# General Service Bulletin

## RTAA/WA/UA

### Compressor Modules

Order Number: **RTAA-SVB10B-EN**

**Figure 1: Date Code**

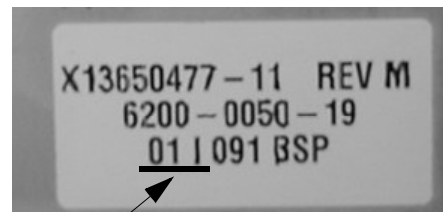
RTAA/WA/UA units built between January 1, 2001 and September 1, 2002 may have the defective component installed in the compressor modules.

The affected modules will have a date between 01 C### and 02 H###. The date code is on a white sticker on top of the module. Refer to the figure below.

**Figure 2: Leads**

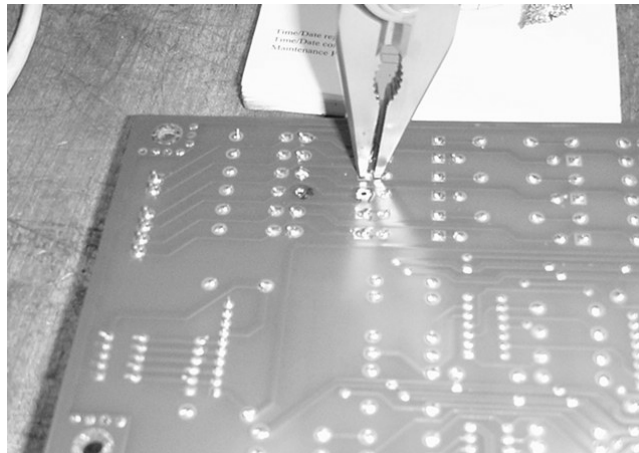
1. Use needle nose pliers to straighten leads. Refer to Figure 2.

**Figure 3: Solder Sucker**

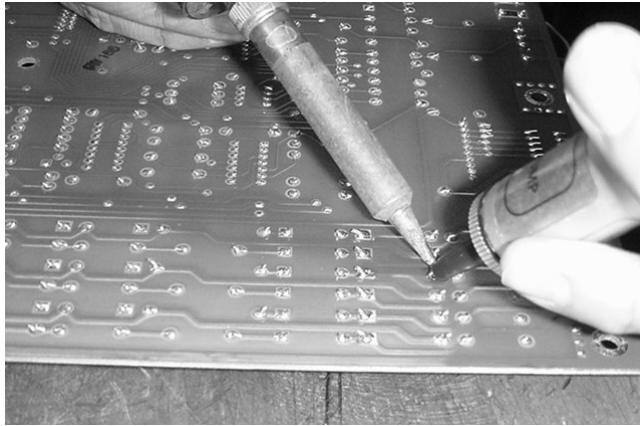
3. With solder iron on one of the diode leads, use solder sucker to draw out solder. Refer to Figure 3.

**Figure 4: Solder Sucker**

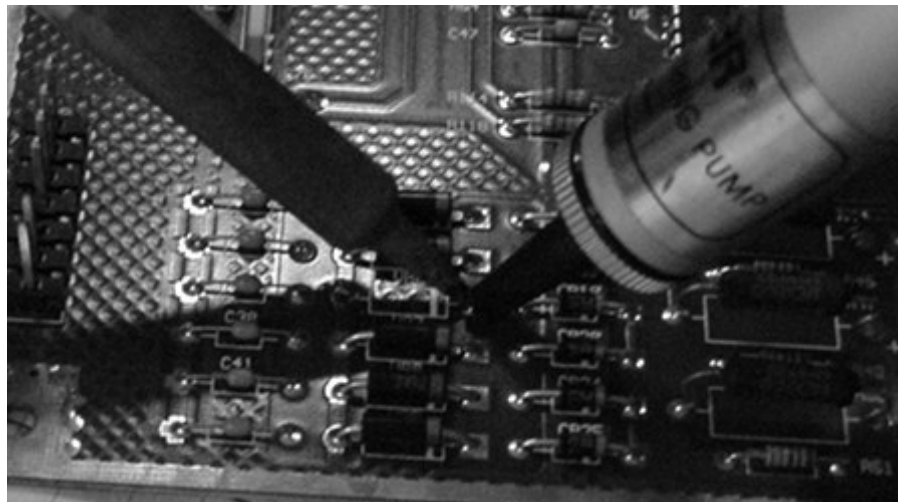
4. Repeat step 3 for the other diode lead.
5. Repeat steps 3 & 4 on other side of the board. Refer to Figure 4.

**Figure 5: Copper Solder Braid**

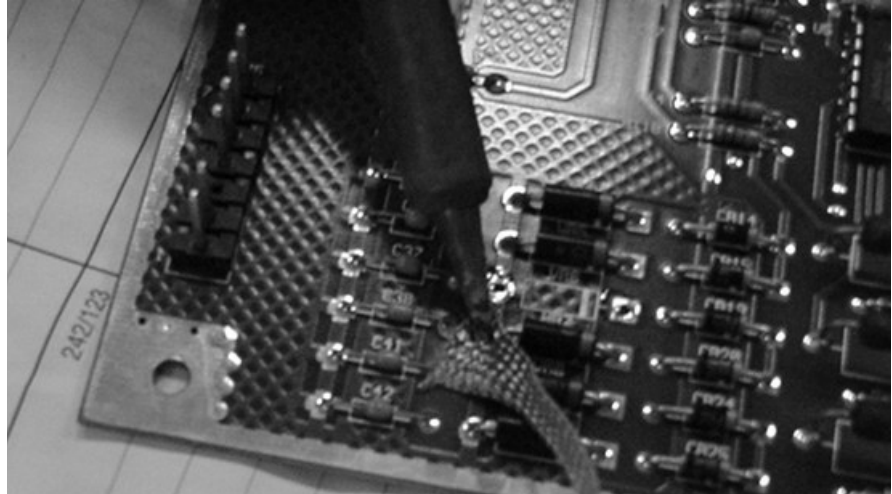
1. Use needle nose pliers to straighten leads. Refer to Figure 2.
2. With copper solder braid covering one of the leads, heat the lead until the solder braid absorbs the melted solder. Refer to Figure 5.
